March 18, 2015  
ECT No. 140365-0001

**Re: Phase II Report Addendum  
Orange County - Waste Cleanup  
Creative Digital Village  
68 acres of land within city limits of Orlando, FL generally located east of Parramore  
Avenue, south of Colonial Drive (S.R. 50), west of Hughey Avenue and  
north of a CSX Railroad  
WCU Site ID: COM\_320731  
BF Site ID No: BF480401007**

Environmental Consulting & Technology, Inc. (ECT) is submitting this Phase II Report Addendum per your letter dated March 02, 2015 (copy provide in **Attachment A**). Each comment is reiterated below in bold followed by ECT's response.

**August 2014 Phase II Environmental Site Assessment Report – Orlando Downtown Recreation Complex and Tennis Centre Parcel**

FIGURE 6.  
DIELDRIN 1-3 FT BLS  
ORLANDO DOWNTOWN RECREATION COMPLEX & TENNIS CENTRE  
CITY OF ORLANDO, ORANGE COUNTY, FLORIDA  
SECTION 26, TOWNSHIP 22S, RANGE 29E  
SOURCE: FDOT Aerial, 2012; ECT, 2015.

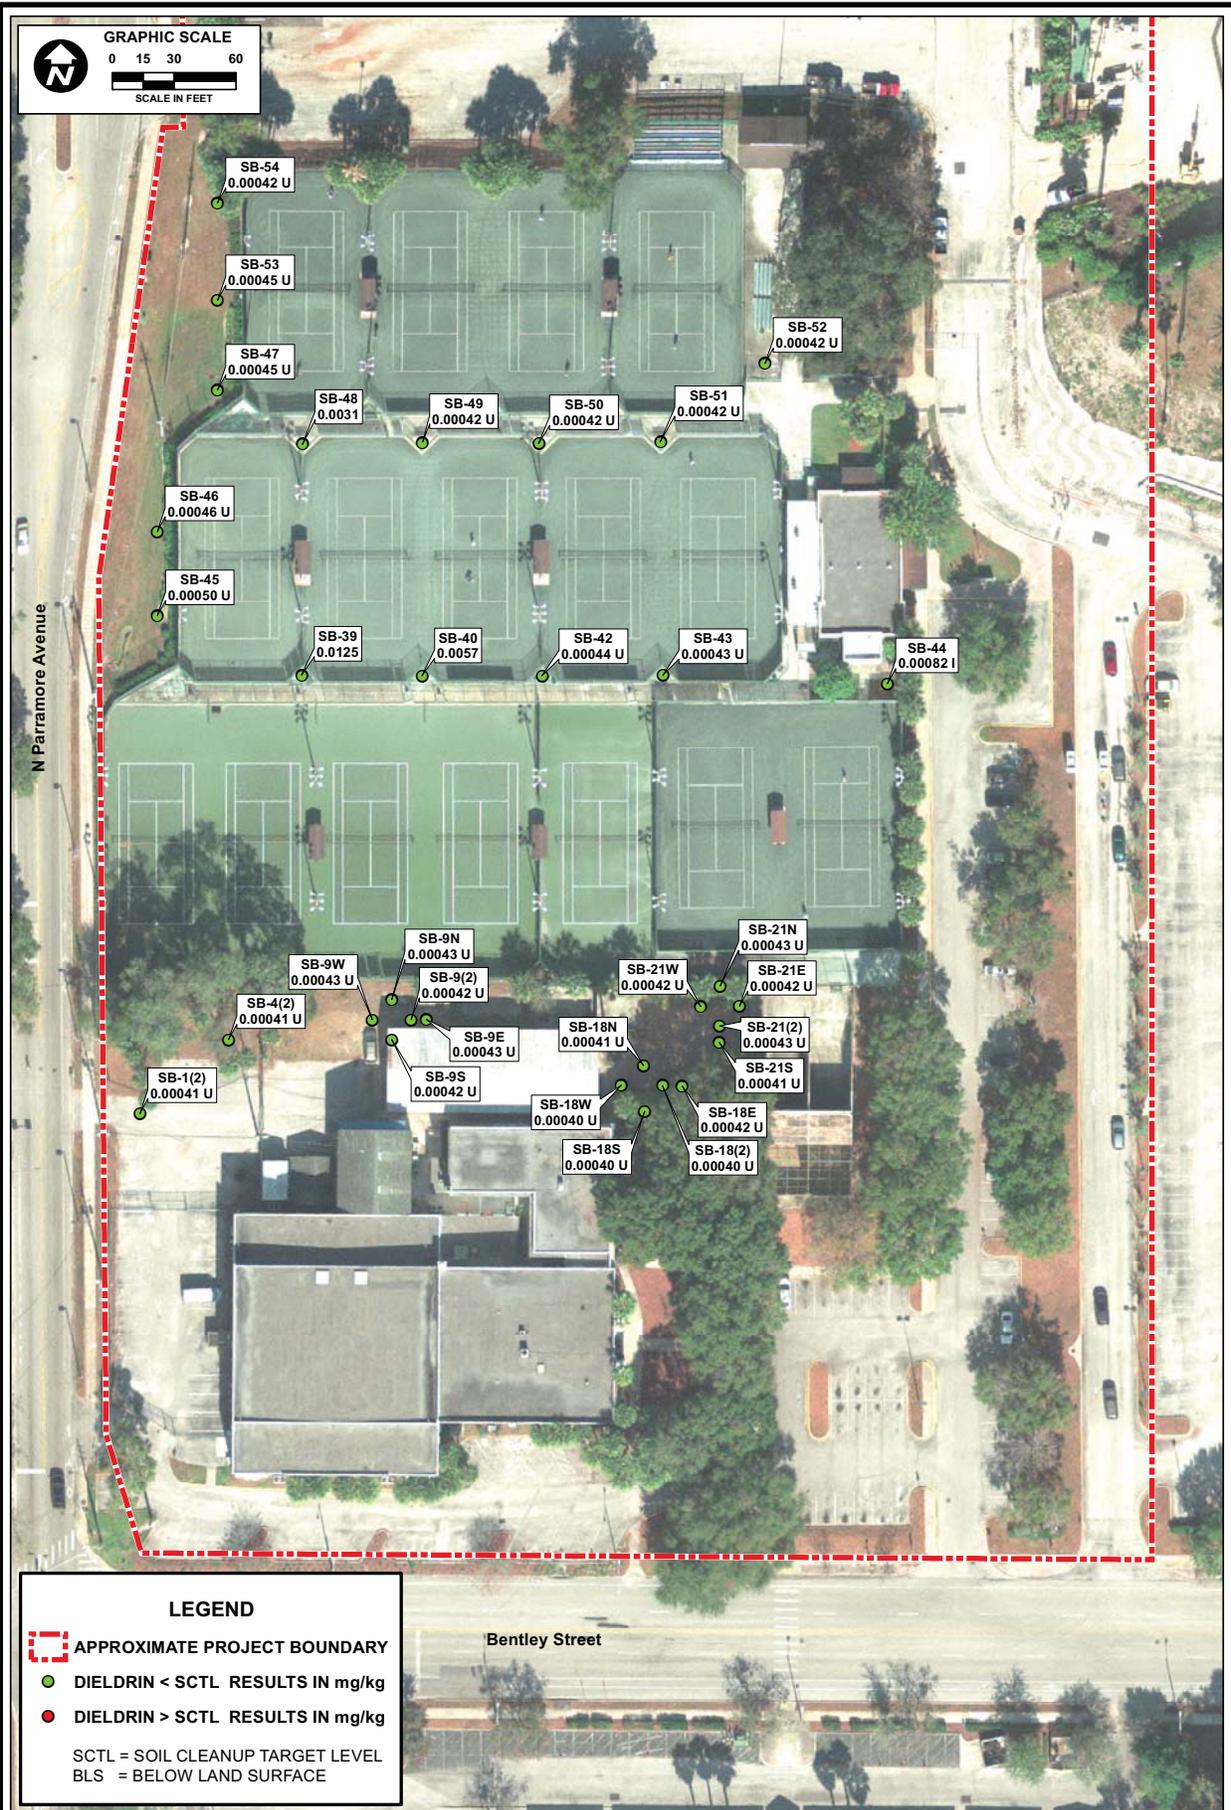
**3. Figure 6 contains symbols which depict whether a soil sample contained a concentration of Dieldrin above or below a SCTL in the 1-3 feet bls sampling interval and Figure 8 contains symbols which depict whether a soil sample contained a concentration of Dieldrin above or below the a SCTL in the 3-5 feet bls sampling interval. Review of these figures indicates that they were constructed using the incorrect values for the Dieldrin SCTLs listed in Tables 3, 4, and 5. Please revise these figures accordingly.**

**4. Figures 5 through 9 do not depict the soil laboratory analytical result for each soil sample location. Please revise these figures to depict the soil analytical result for each soil sample location.**

3. Figures 6 contains symbols which depict whether a soil sample contained a concentration of Dieldrin above or below a SCTL in the 1-3 feet bls sampling interval and Figure 8 contains symbols which depict whether a soil sample contained a concentration of Dieldrin above or below the a SCTL in the 3-5 feet bls sampling interval. Review of these figures indicates that they were constructed using the incorrect values for the Dieldrin SCTLs listed in Tables 3, 4, and 5. Please revise these figures accordingly.

4. Figures 5 through 9 do not depict the soil laboratory analytical result for each soil sample location. Please revise these figures to depict the soil analytical result for each soil sample location.

Figures 6 and 8 have been revised to reflect the above comment. All revised Figures are provided in **Attachment B**.

Figures 5 through 9 have been revised to reflect the above comment. Revised Figures are provided in **Attachment B**.

FIGURE 12.  
GROUNDWATER ELEVATION AND FLOW DIRECTION - JULY 21, 2014  
ORLANDO DOWNTOWN RECREATION COMPLEX & TENNIS CENTRE  
CITY OF ORLANDO, ORANGE COUNTY, FLORIDA  
SECTION 26, TOWNSHIP 22S, RANGE 29E  
SOURCE: FDOT Aerial, 2012; ECT, 2015.

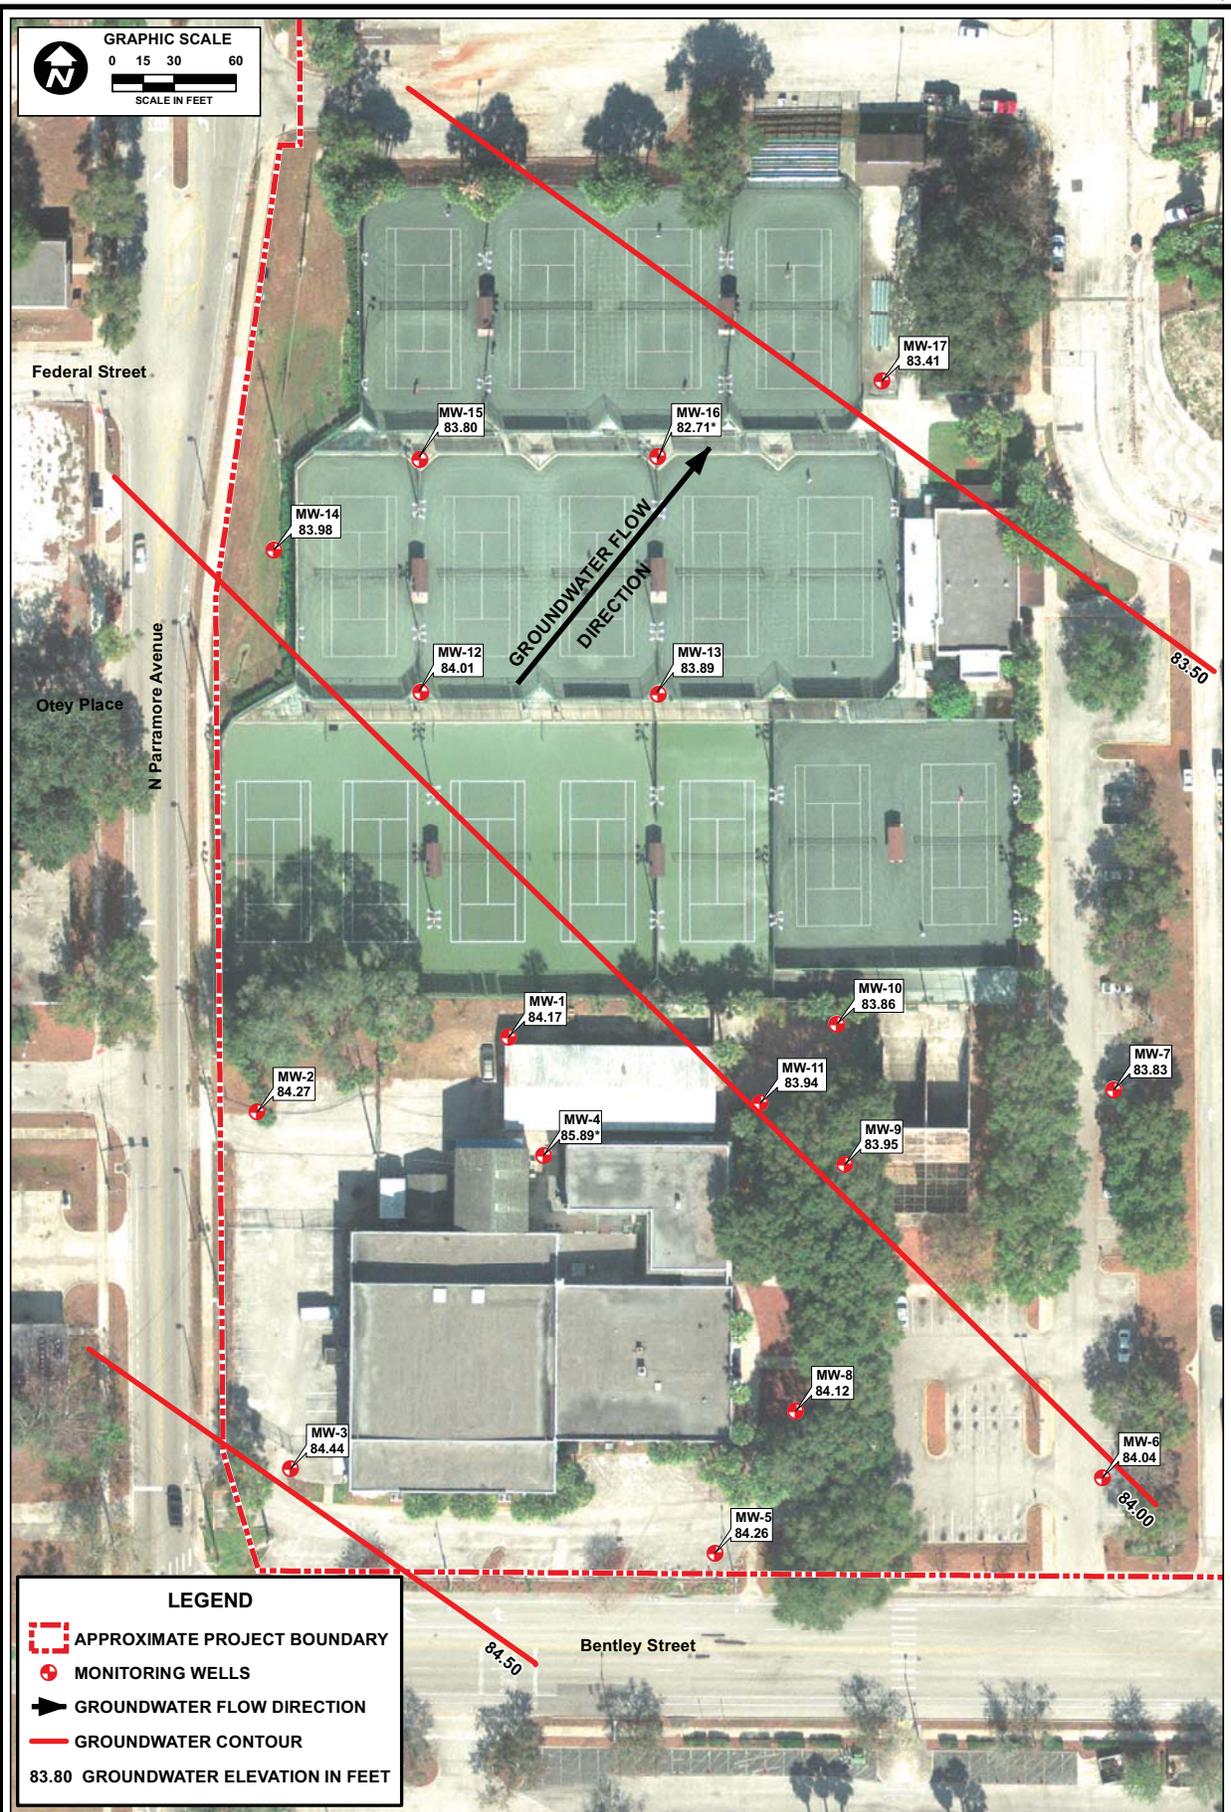
**1. Figure 12 depicts the groundwater elevations and flow direction on July 21, 2014. However, there are no groundwater elevation isocontours depicted on the map as required by Rule 62-780.600(8)(9), Florida Administrative Code (F.A.C). Please revise Figure 12 to depict groundwater elevation contours and the groundwater flow direction.**

1. Figure 12 depicts the groundwater elevations and flow direction on July 21, 2014. However, there are no groundwater elevation isocontours depicted on the map as required by Rule 62-780.600(8)(9), Florida Administrative Code (F.A.C). Please revise Figure 12 to depict groundwater elevation contours and the groundwater flow direction.

Figure 12 has been revised to reflect the above comment. Revised Figures are provided in **Attachment B**.
